**CMD 25-H12.45**

**Written Submission from the  
Ya'thi Néné Lands and Resources  
Office**

License application to prepare a site for  
and construct its Rook I uranium mine and  
mill project

# YA'THI NÉNÉ LANDS AND RESOURCES INTERVENTION

FIGURE 1: MAP SHOWING EXTENT OF MINERAL DISPOSITIONS AND ACTIVE PERMITS WITHIN NUHENÉNÉ AS OF SUMMER 2025

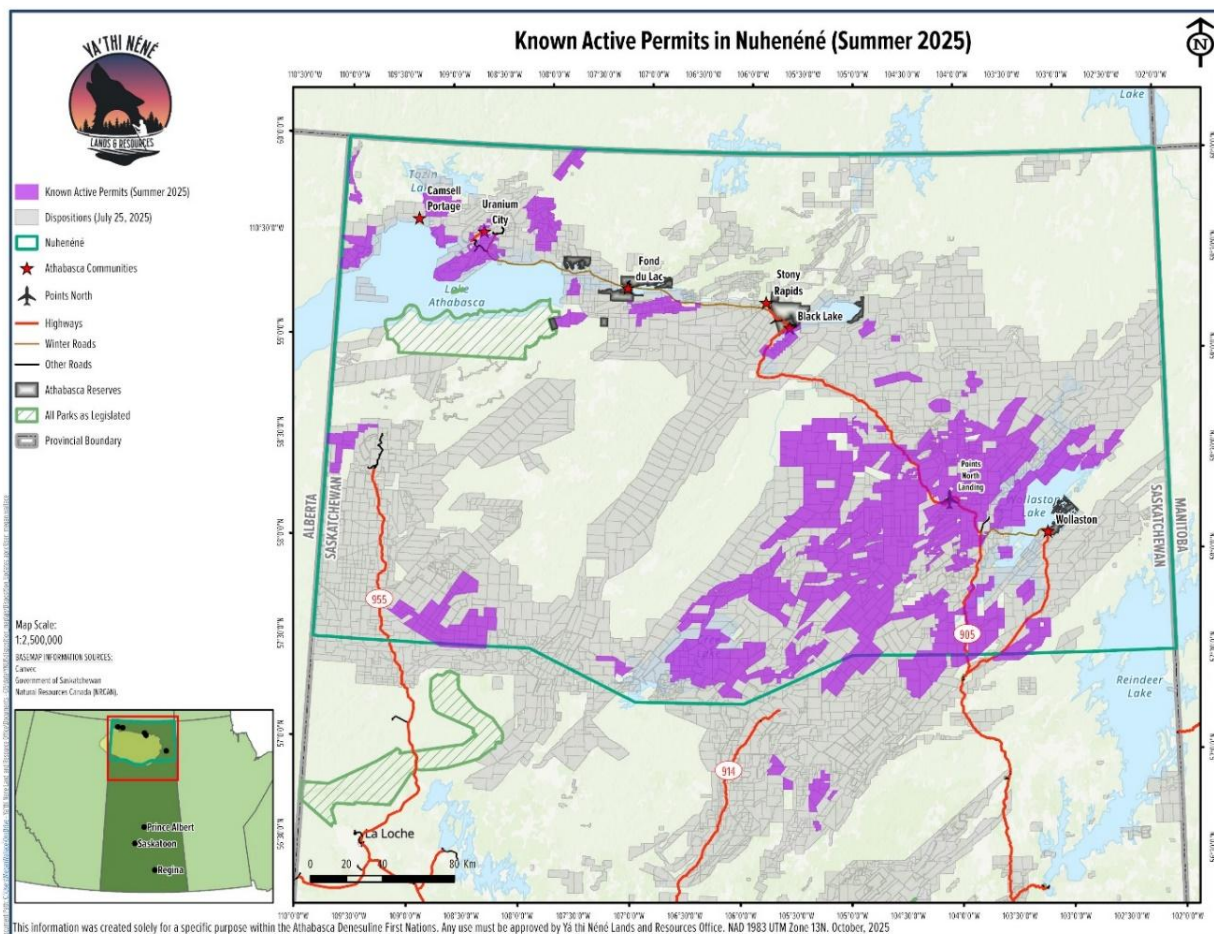
We retain our concern regarding cumulative effects, despite the acceptance of such effects on caribou by NexGen. The total extent of human disturbance on the landscape was not sufficiently accounted for in the EIS. Our own estimate shows that the total amount of known linear disturbance within Nuhenéné is more than 20,400 km and growing. Furthermore, looking into the future, the total number of current mineral claims and exploration activity is also increasing rapidly (see Figure 1). Importantly, the Rook I Project is not occurring in isolation; its development has the potential to exert a compounding influence that accelerates additional mineral exploration and associated disturbance both within and beyond the local and regional study areas as defined by NexGen.

Looking forward, the cumulative terrestrial effects associated with increased exploration activity emphasize the need for improved regional land management approaches. While YNLR recognizes that broader solutions such as a provincial land management policy are beyond the scope of this hearing, interim measures could meaningfully reduce future impacts. These include clearer siting guidelines intended to minimize the creation of new linear disturbances, requirements for the submission of accurate and complete spatial data (including shapefiles) for all new and refurbished linear disturbances with associated dates and usage details, and the inclusion of enforceable mitigation and restoration requirements within surface access permits.
